CALIFORNIA COASTAL COMMISSION

Filed: 9/30/1999
 49th Day: 11/18/1999
 180th Day: 3/28/2000
 Staff: CP-LB
 Staff Report: 11/17/1999
 Hearing Date: December 9, 1999
 Commission Action:

STAFF REPORT: REGULAR CALENDAR**APPLICATION NUMBER:** 5-99-367**APPLICANT:** Silver Strand Custom Homes, LLC**AGENT:** Patrick Cunningham, C&C Partners**PROJECT LOCATION:** 10 20th Avenue, Venice, City of Los Angeles, Los Angeles Co.**PROJECT DESCRIPTION:** Construction of a three-story, 29.5-foot high, 3,236 square foot duplex with two two-car garages on a vacant lot.

EXHIBIT # 3

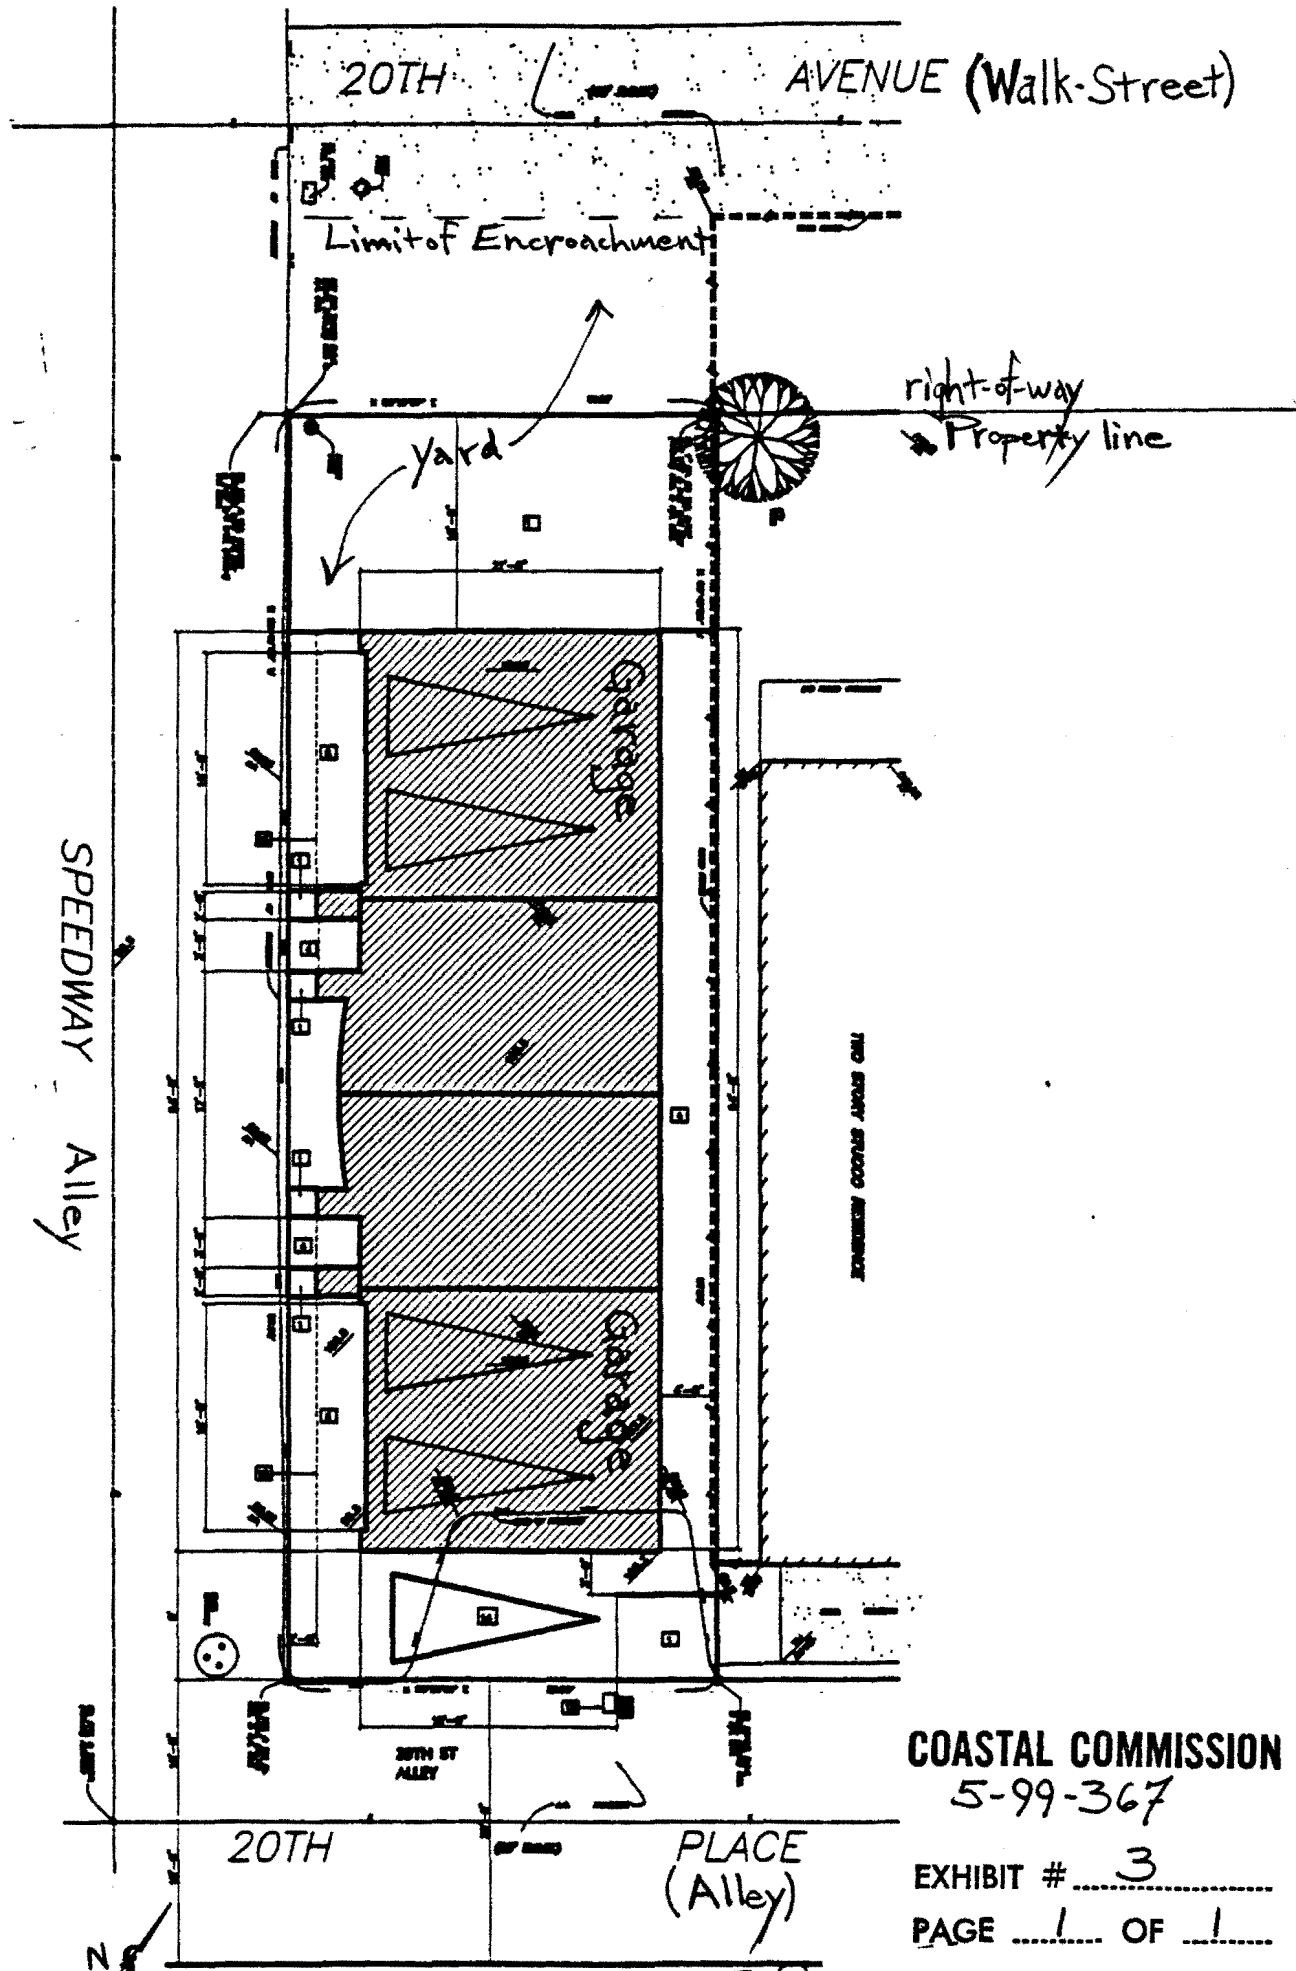
The applicant proposes to provide five on-site parking spaces within two ground floor garages (two-cars each) and a one-space carport (Exhibit #3). Vehicular access to the parking is proposed from Speedway alley (Exhibit #2). The five proposed on-site parking spaces provide an adequate parking supply for the proposed duplex. Therefore, the proposed project conforms to the Commission's parking standards for the North Venice area.

A minimum of five (5) parking spaces shall be provided and maintained on the site to serve the approved duplex. Parking and vehicular access is not permitted on any portion of the 20th Avenue right-of-way.

EXHIBIT # 4

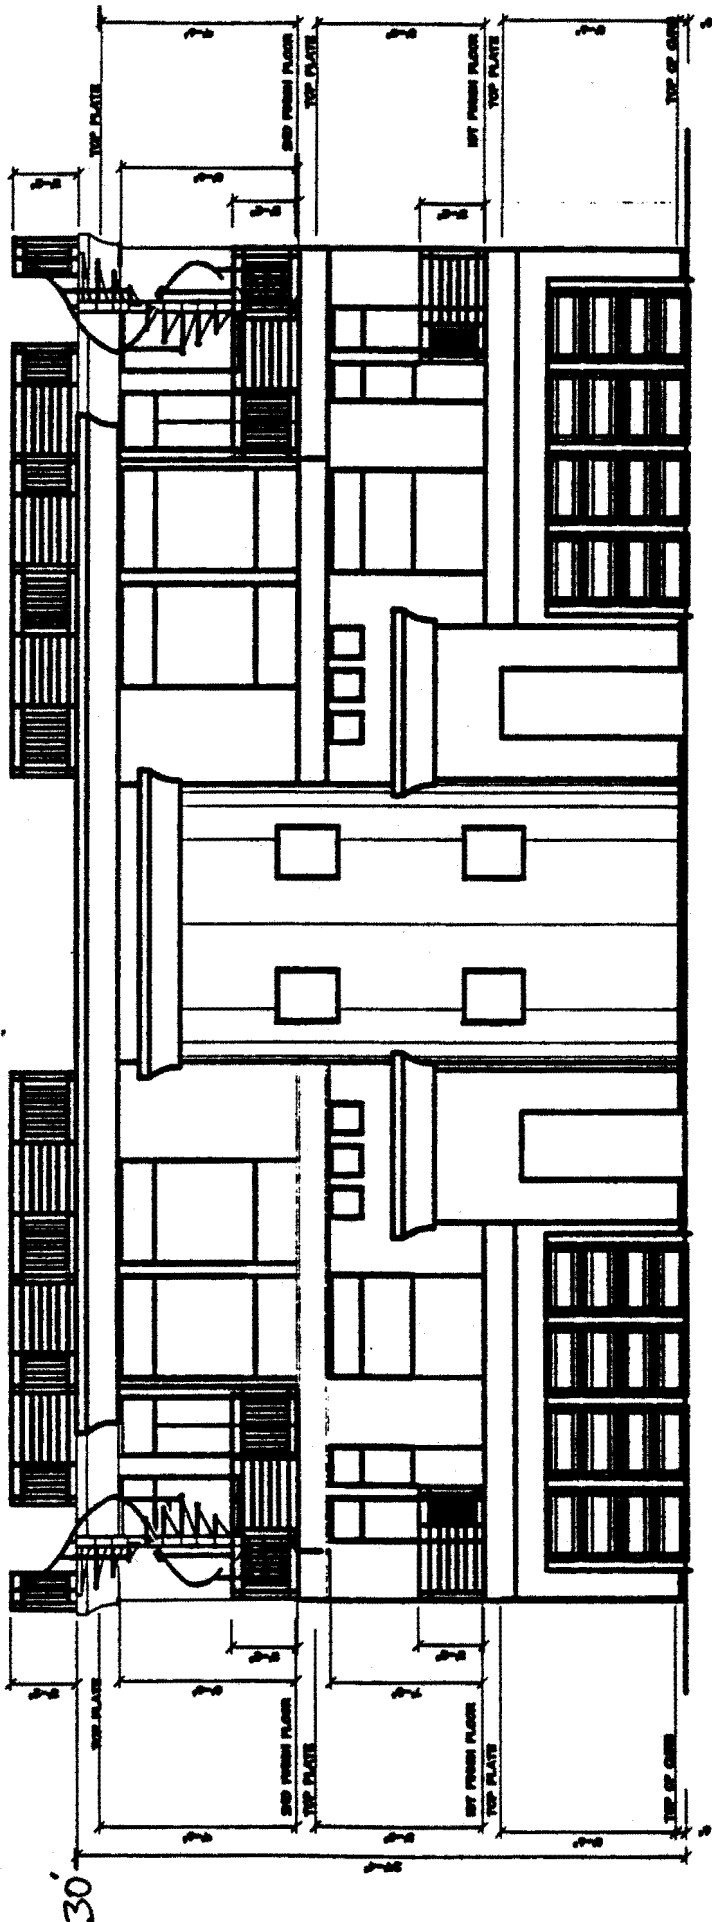
The proposed project 29.5-foot high apartment building, which is located on a historic Venice walk street (20th Avenue), does not conform to the draft LUP's 28-foot height limit (Exhibit #4). The applicant contends that the proposed project was designed using the Commission's Interpretive Guideline height limit of 30 feet, and the City's ICO height limit of 30 feet. The City did not require the proposed project to conform to the new 28-foot height limit for development along walk streets when it issued a preliminary approval for the proposed project on June 28, 1999. The City Planning Department issued Approval in Concept No. 99-088 for the proposed 29.5-foot high duplex on June 28, 1999, and the draft Venice LUP was adopted by the Los Angeles City Council on October 29, 1999.

The proposed project has a 29.5-foot high flat roof as measured from the centerline of the fronting street, 20th Avenue (Exhibit #5). No roof access stairway enclosures are proposed to exceed the 29.5-foot high roof elevation. Access to the proposed roof deck is provided by two unenclosed spiral stairways (Exhibit #4). The only portions of the proposed structure that exceed the 29.5-foot high roof level are roof deck railings and roof equipment. The highest part of the proposed structure is the roof deck railing that reaches approximately 32.5 feet above the elevation of 20th Avenue (Exhibit #4).

Prior to issuance of the coastal development permit, the applicant shall submit revised plans for the review and approval of the Executive Director that show that the top of the roof does not exceed 28 feet in elevation above the centerline of the 20th Avenue right-of-way. The proposed roof deck railings may extend 42 inches over the 28-foot roof height limit. A roof access structure exceeding the 28-foot height limit is not permitted. The applicant shall construct and maintain the project as shown on the plans approved by the Executive Director.

EXHIBIT # 6
PAGE 1 OF 1

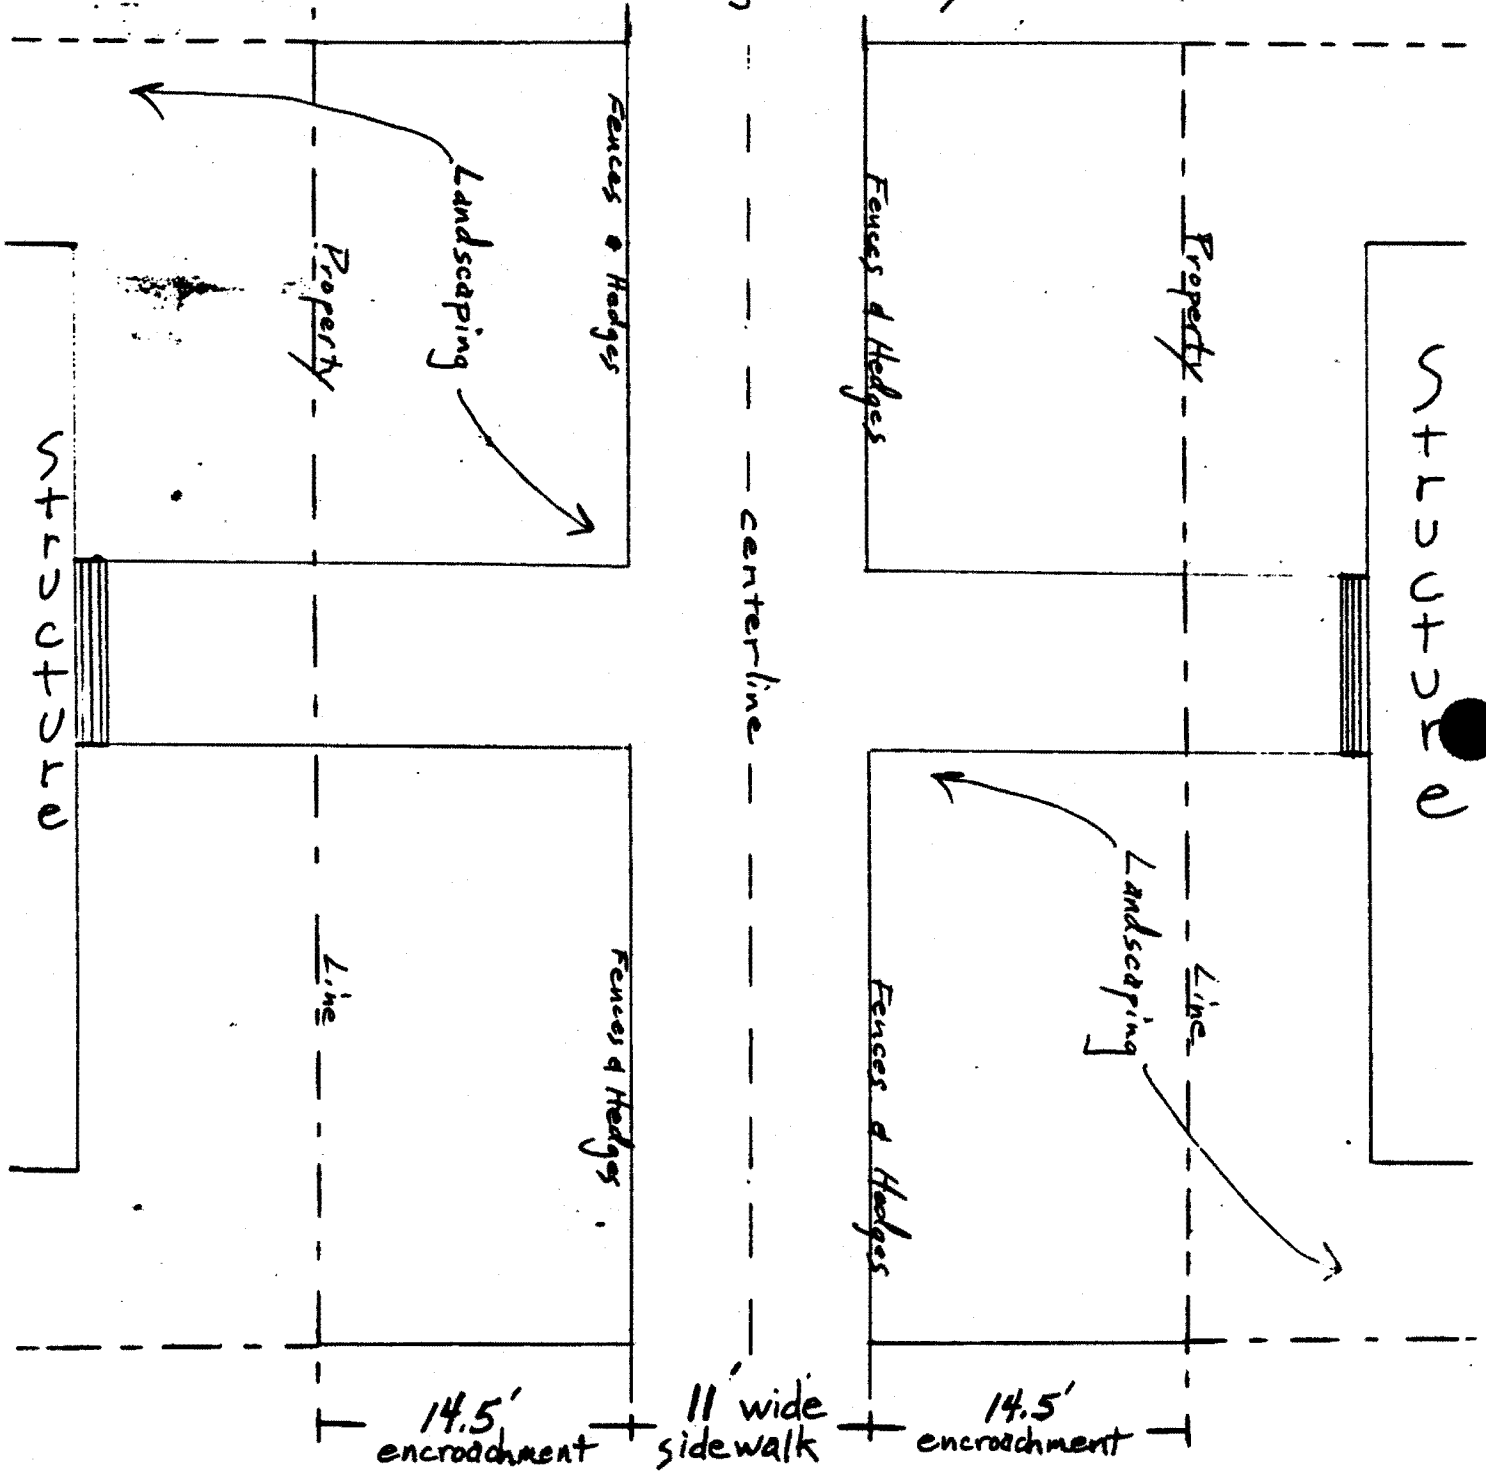
In this case, 20th Avenue is a forty-foot wide public right-of-way. An eleven-foot wide sidewalk provides public access down the center of the forty-foot wide public right-of-way (Exhibit #6). The single family and multi-family residences which front the walk street have been allowed to improve and privatize their respective frontage area of the right-of-way with small landscaped yards. Each yard encroaches about 14.5 feet into the right-of-way (Exhibit #6). The City often requires that new development on the walk streets improve the fronting right-of-way areas in order to preserve the special character of the walk streets. A minimum ten-foot wide public sidewalk, however, must be maintained to provide public access down the center of the walk street right-of-way. The lush
